A3.3.41 NP RESPONSE TO NRW REQUEST FOR ILLUSTRATIVE EXAMPLES OF AVIATION LIGHTING EFFECTS

Subject: RE: Y Bryn Wind Farm - Aviation Lighting scheme, VPs and ZTVs NRW:01273097

Y Bryn Wind Farm

Appropriate Noise Limits

Nordex N163 STE $L_{eq} = 109.2$
No CCVC
Blue = 40 dB L_{eq} Green = 35 dB L_{eq} Yellow = 30 dB L_{eq}

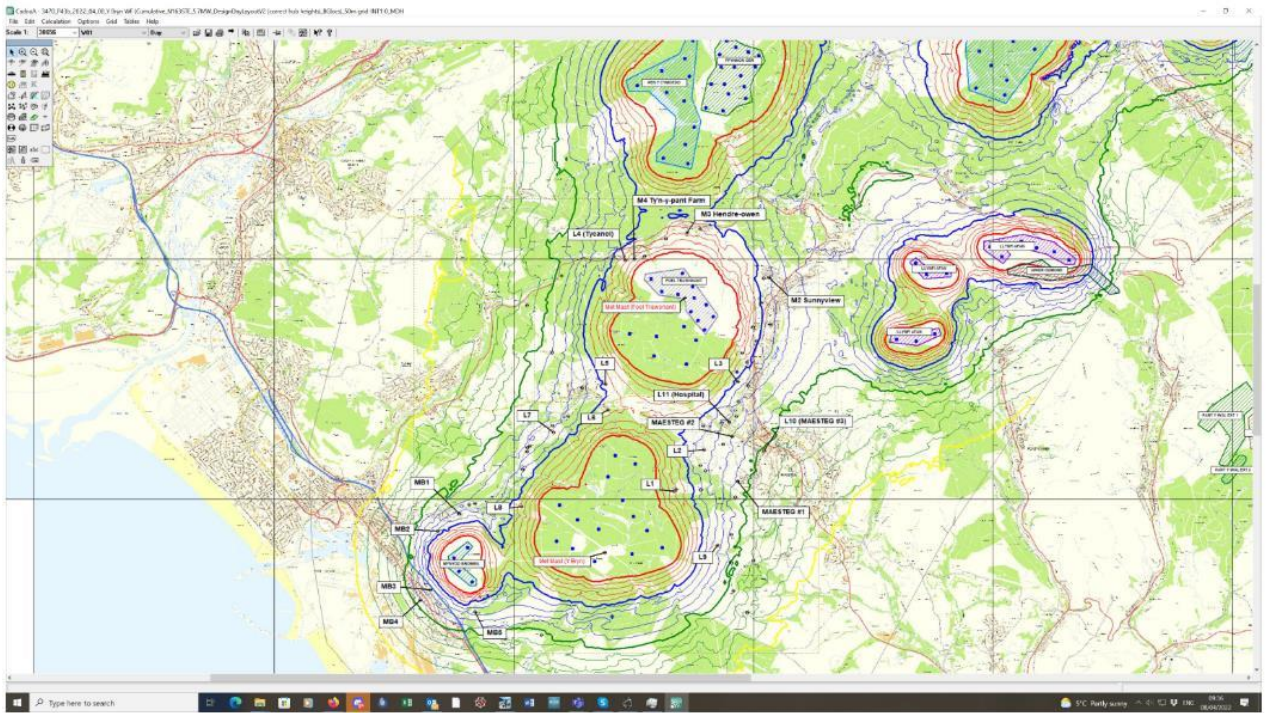
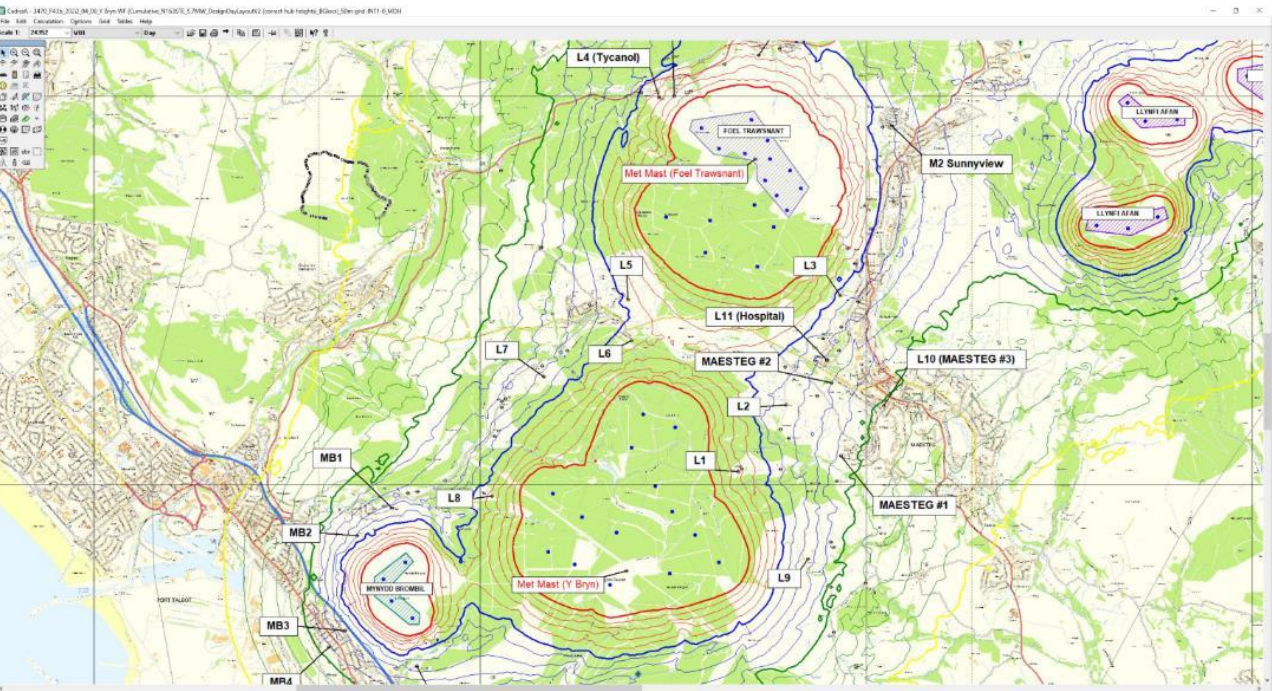
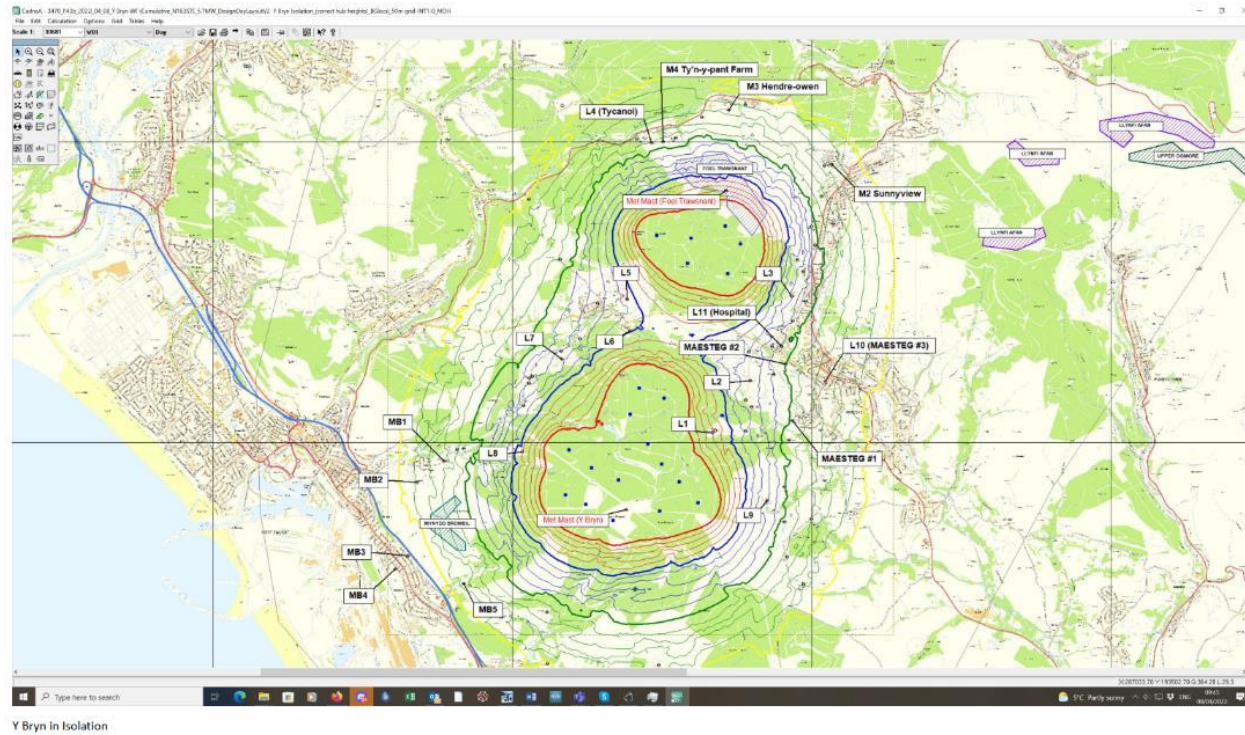
Following our meeting earlier this week it was requested that we provide some contour plots for the site both cumulatively and in isolation.

They do not include CCVC but this is because I need someone in Salisbury Office to be back at their desk to run the model for contours and they are away until next week. Once these have been undertaken I can send through a better quality figure.

The source level we have assumed is $L_{WA} = 109.2$ dB, i.e. Published = $107.2 + 2$ dB

Figure – Lines of Sight over NRW Long Term Felling Plan
Example Photowire (VP2 – Maesteg Golf Course)

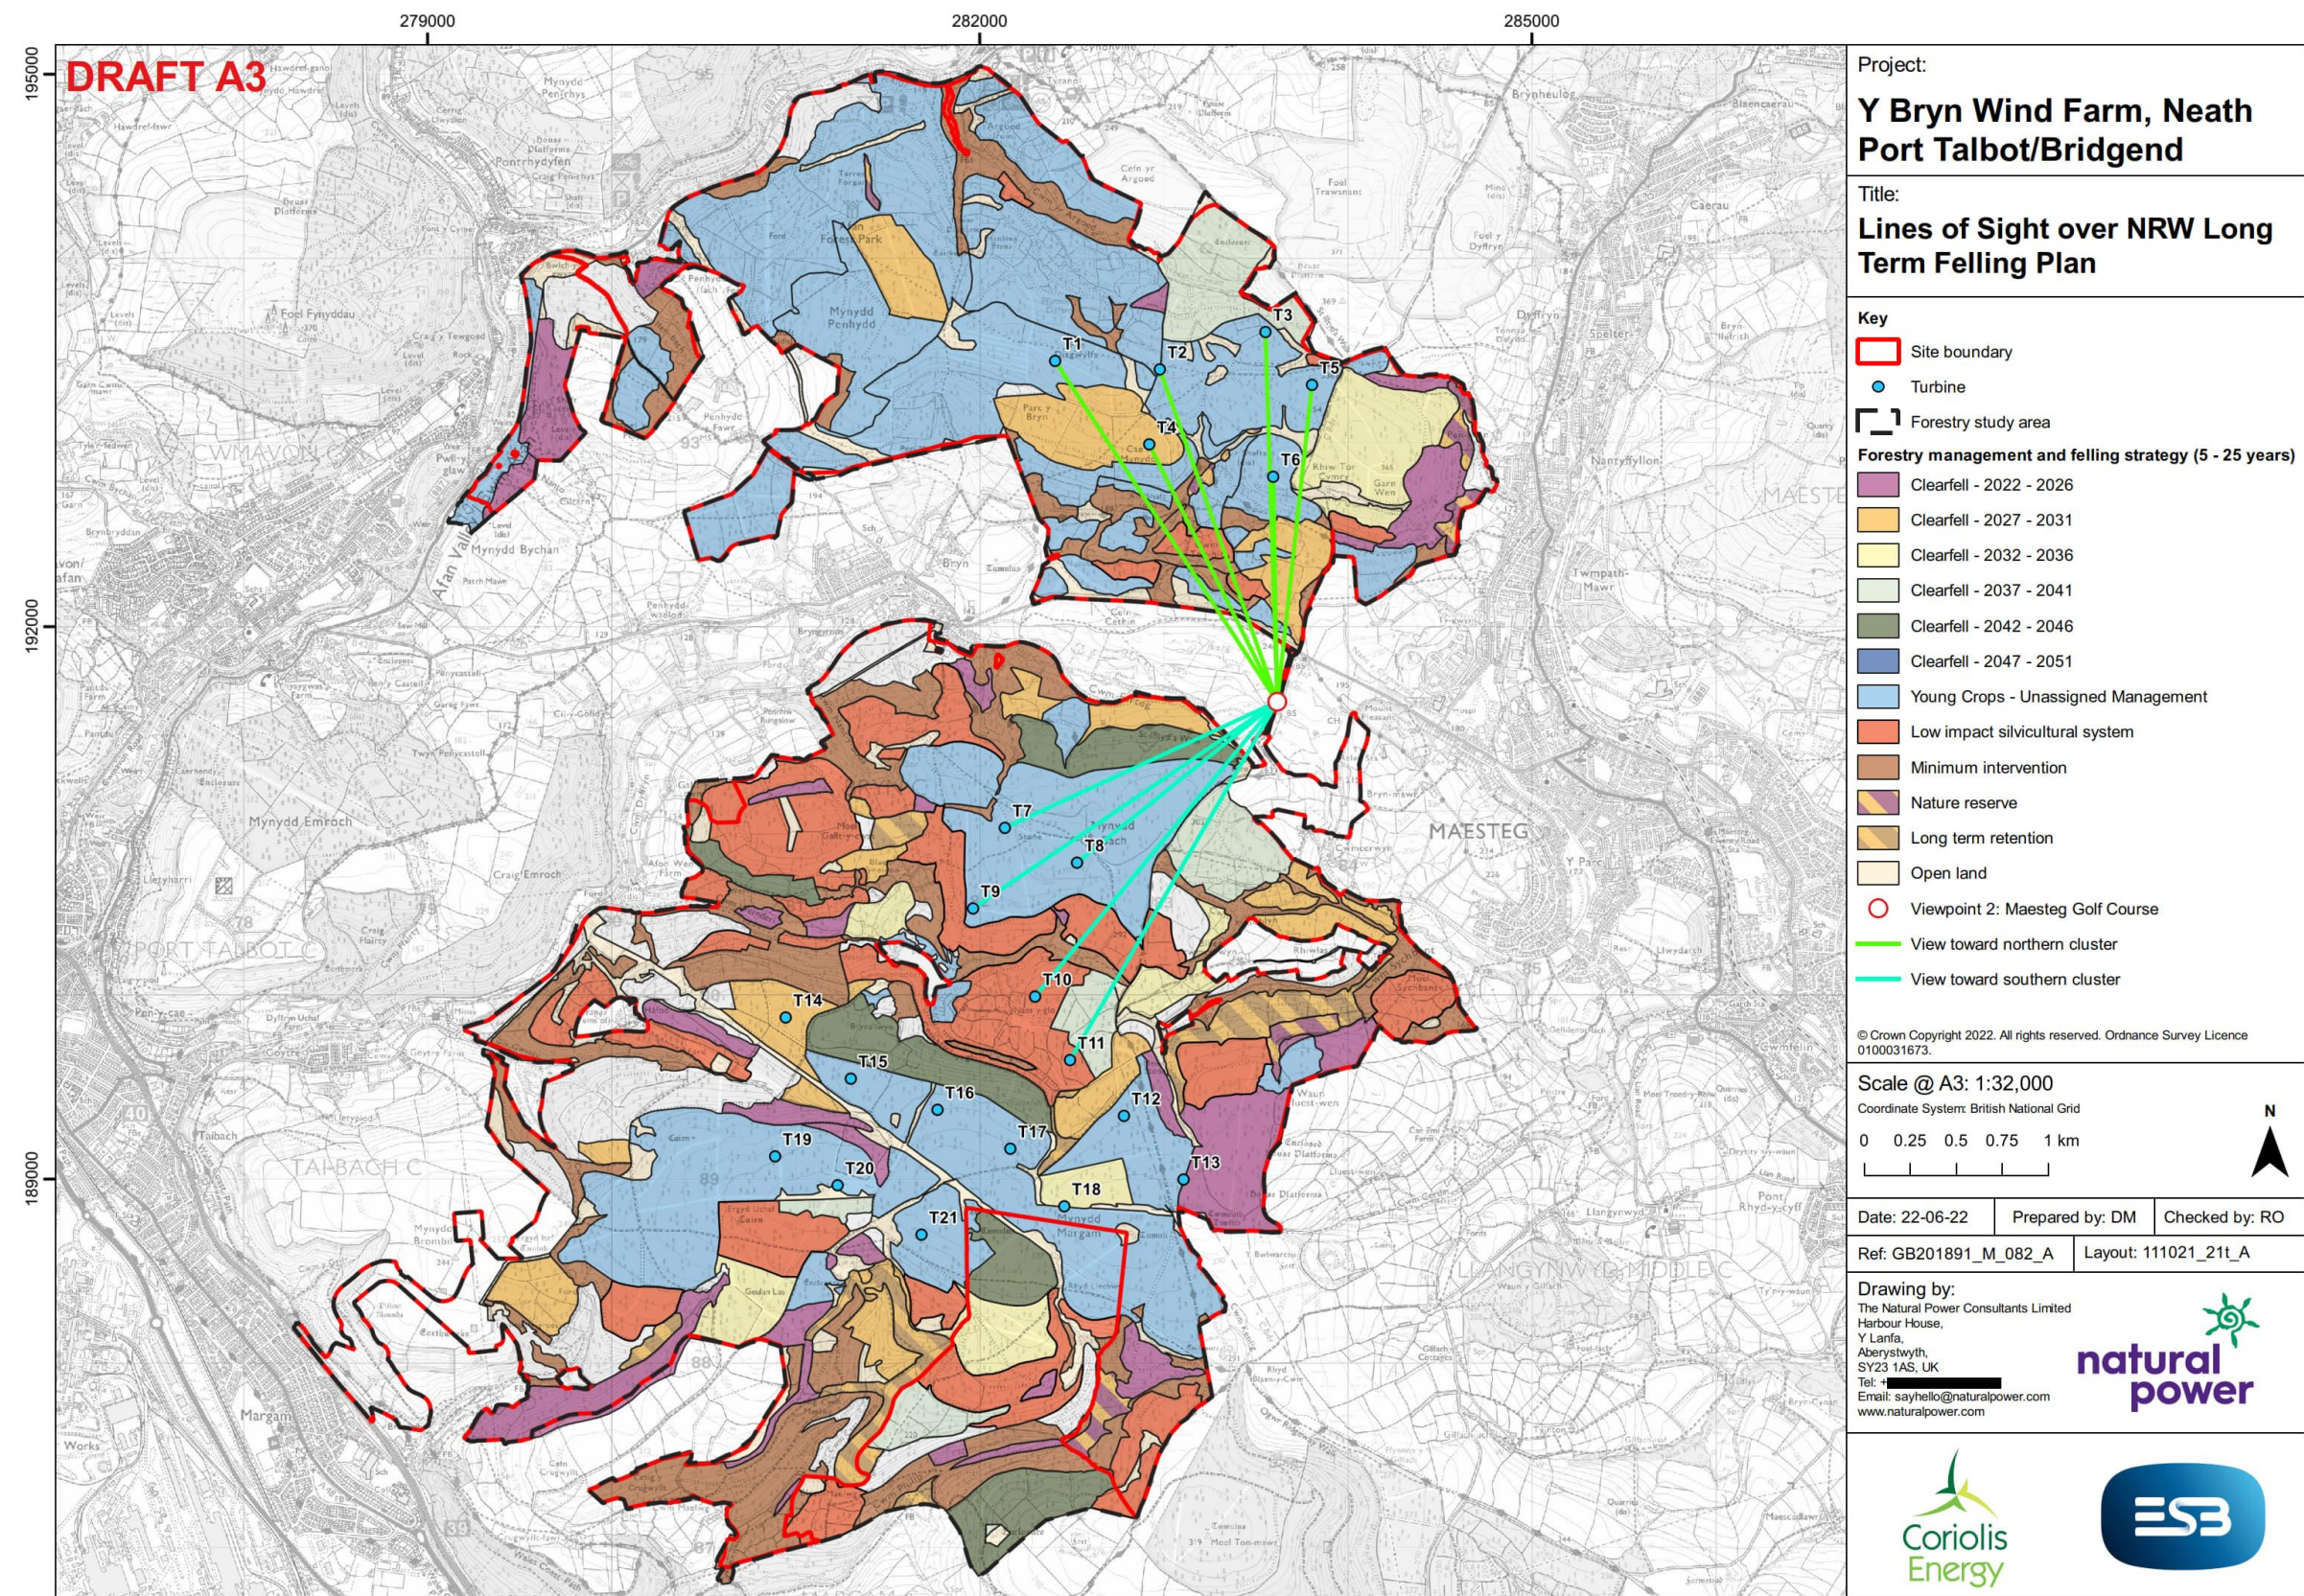
There are two areas of forestry currently planned for felling in direct line-of-sight to the nearest turbines, T7 and T8, within the southern section. Both forestry coupes are approximately 400 m from the VP to the south-west. The coupe shaded dark orange colour on Figure – Lines of Sight over NRW Long Term Felling Plan is due to be clear felled between 2027 to 2031 and the coupe shaded dark green between 2042 to 2046. Immediately beyond these forestry coupes, further to the south-west on the Mynydd Bach plateau, is an extensive block of unassigned forestry which was planted between 1980 to 1999. Following felling of the above forestry blocks to the front of the young forestry, which is scheduled to be completed by 2046, the assigned management (shaded light blue) will have an additional 24 years of growth and to have reached a mature height being 47 to 66 years old. This area of forestry, will effectively duplicate the degree of screening currently provided by the coupes due to be harvested from 2027 onwards. The two coupes harvested will, in addition, it is assumed be replanted and will offer further screening from year 2031 onwards. Following the harvesting of forestry in 2042, the blade tips of T9, T10 and T11 should remain screened from view to a degree by the unassigned forestry.

Within the northern section, the forestry coupe located on Caer Mynydd/Parc y Bryn (shaded orange) is due be harvested between 2027 and 2031. Following this, there will potentially be increased visibility towards the lower part of the tower to T4 as well as to T1. However, the unassigned management areas surrounding the forestry coupe (planted 2004 and 2014) will continue to establish and will reimpose a degree of screening that currently exists to T4. However, the forestry coupe titled ‘minimum intervention crops’ and also the coupe of ‘Low impact silvicultural system’ will also contribute to the degree of screening provided to the towers of turbines T4 and also T6. For all other turbines there will be no perceptible change following forestry management during the lifetime of the proposed development from currently planned management.

Evaluations for magnitude of impacts, both individually and cumulatively, will remain as assessed as there will no discernible change to views following implementation of the forestry management.
